## Commission of Architectural Review

7. COA-169126-2025	Final Review	Meeting Date: 7/22/2025
Applicant/Petitioner	Mary Lorino	
Project Description	Rehabilitate a single-family building and construct an addition	
Project Location		
Address: 2114 M Street		
Historic District: Union Hill		
High-Level Details: The building is a c. 1859 wood-framed single-family structure composed of three interconnected volumes, reflecting multiple phases of development. The home is in significant disrepair, with structural failures at the foundation, wall framing, and roofing systems. The applicant proposes a substantial rehabilitation project that will preserve key historic elements (such as porch cornices and wood siding) while reconstructing deteriorated elements and introducing modest additions at the rear. The project includes selective demolition, structural rebuilding, restoration of siding and porches, new wood and aluminum-clad windows, roofing replacement, and the addition of a new outbuilding.

Staff Recommendation	Approval, with Conditions	
Staff Contact	Yara Iwaz, Yara.Iwaz@RVA.gov, (804)646-6031	
Previous Reviews	<ul style="list-style-type: none"><li>N/A</li></ul>	
Staff Recommendation

FRONT (South) ELEVATION

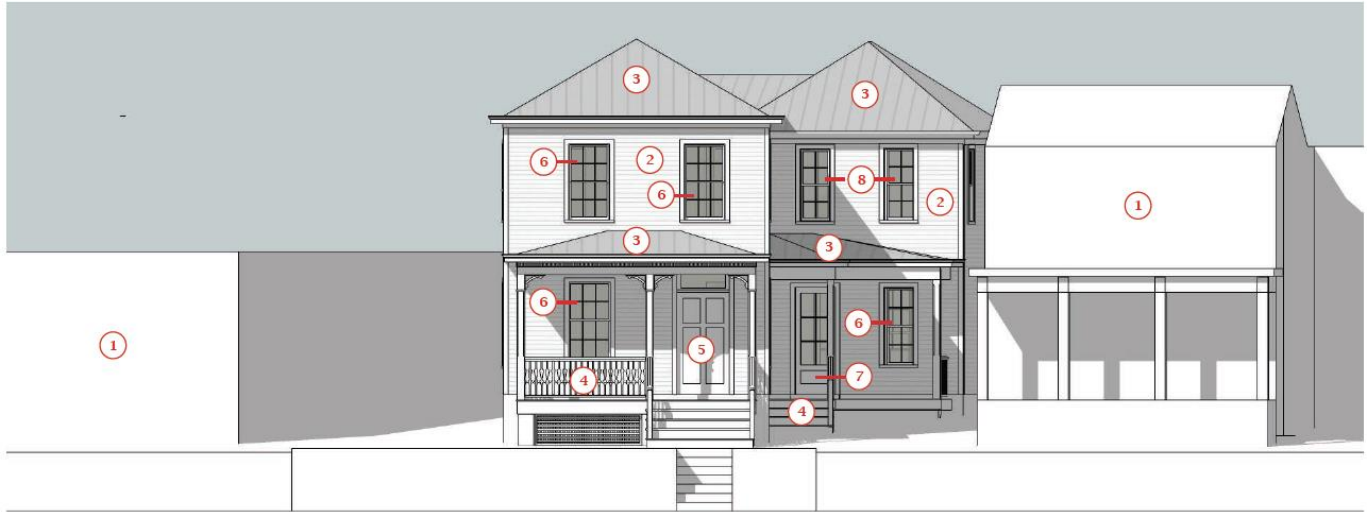
Porches & Porch Details, page 49	<i>1. Porch railings and balustrades are important character-defining features of historic buildings. The proportions of these railings are a significant contributing feature to the appearance of both the individual structure and the</i>	<p><b>Porch &amp; Roof Restoration:</b></p> <ul style="list-style-type: none"> <li>• The proposal includes retaining the original porch roof framing, fascia, and dentils, and rebuilding deteriorated elements, notably brick masonry piers. Composite tongue-in-groove decking is proposed on the front porch. Additionally, the proposed elevations suggest that the turned wood posts will</li> </ul>

<p><i>character of the entire neighborhood.</i></p>	<p>be replaced with decorative sawn pickets to match historic imagery.</p> <ul style="list-style-type: none"> <li>The proposal suggests that decorative brackets will be installed on either side of the porch posts; however, the drawings show a bracket that is a simplified design than what is seen in historic documentation. <u>Staff supports a simplified interpretation of the historic design of the brackets.</u></li> </ul> <p><u>Staff recommends approving the porch reconstruction on existing piers and the repair of piers to be structurally sound; installation of T&amp;G decking to match direction of existing boards. Staff recommends confirming final design of the porch posts and brackets for administrative approval.</u></p>
Doors & Windows, page 49	<p>1. <i>The size, proportion and spacing patterns of door and window openings on a new addition should follow patterns established by the original building. Windows on most commercial and residential properties throughout Old and Historic Districts have a vertical orientation. Wide, horizontal so-called "picture windows" on new additions are strongly discouraged.</i></p> <p>2. <i>The architectural appearance of original windows should be used as models for new windows. Changes in the sash, depth or reveal, muntin configuration, frame or glazing is strongly discouraged. New glass should be clear without reflective coatings, to be compatible with original glass.</i></p> <p>3. <i>The size, proportion, and spacing patterns of doors and window openings on free standing, new construction should be compatible with patterns established within the district.</i></p>	<p><i>Windows &amp; Doors:</i></p> <ul style="list-style-type: none"> <li>New wood double-hung windows with 6-over-6 simulated divided lites and spacer bars are proposed on the front façade; other windows include aluminum-clad in compatible configurations. New casement-style windows are located at the rear of the building as well as a side elevation.</li> <li>First story façade picture window will be converted to a single window, which is more in-keeping with the historic configuration of the fenestration.</li> </ul> <p><u>Staff recommends approval of wood 6-over-6 SDL windows on front elevation, and approving aluminum-clad SDL windows elsewhere. Submit full window specifications for final staff approval.</u></p> <ul style="list-style-type: none"> <li>Existing doors are proposed to be restored or replaced in kind. The front door will be replaced with an in-kind design; the rear non-original door will be removed for structural safety and will be replaced with a new wood door with lite and transom.</li> </ul> <p><u>Staff recommends approving replacement and/or restoration of doors in historically appropriate configurations with in-kind elements, as well as removing non-original doors on rear elevation.</u></p>

<ul style="list-style-type: none"> <li>• Approve use of composite or fiber cement trim where necessary; limit use of PVC to secondary elevations</li> <li>• Approve porch reconstruction using original elements where feasible; confirm final porch post and decorative bracket design for staff review; approve use of tongue-and-groove composite decking</li> <li>• Approve wood 6-over-6 simulated divided lite windows with spacer bars on the front; approve aluminum-clad windows elsewhere. Final window specifications to be submitted for staff review. Approve in-kind door replacement and removal of non-original rear door</li> <li>• Approve replacement of the standing seam metal roof with compatible material and use of TPO membrane on flat roof additions; submit final roofing material for review.</li> <li>• Approve two subordinate rear additions with compatible design and materials; confirm all final colors and materials with staff. Approve minor roof height increase on Volume 1, ensuring volume hierarchy is maintained. Approve rear shed construction.</li> <li>• Approve restoration and expansion of brick paving, removal of chain link and CMU wall, and construction of new rear privacy fence. Confirm that new fence height complies with zoning regulations.</li> </ul>
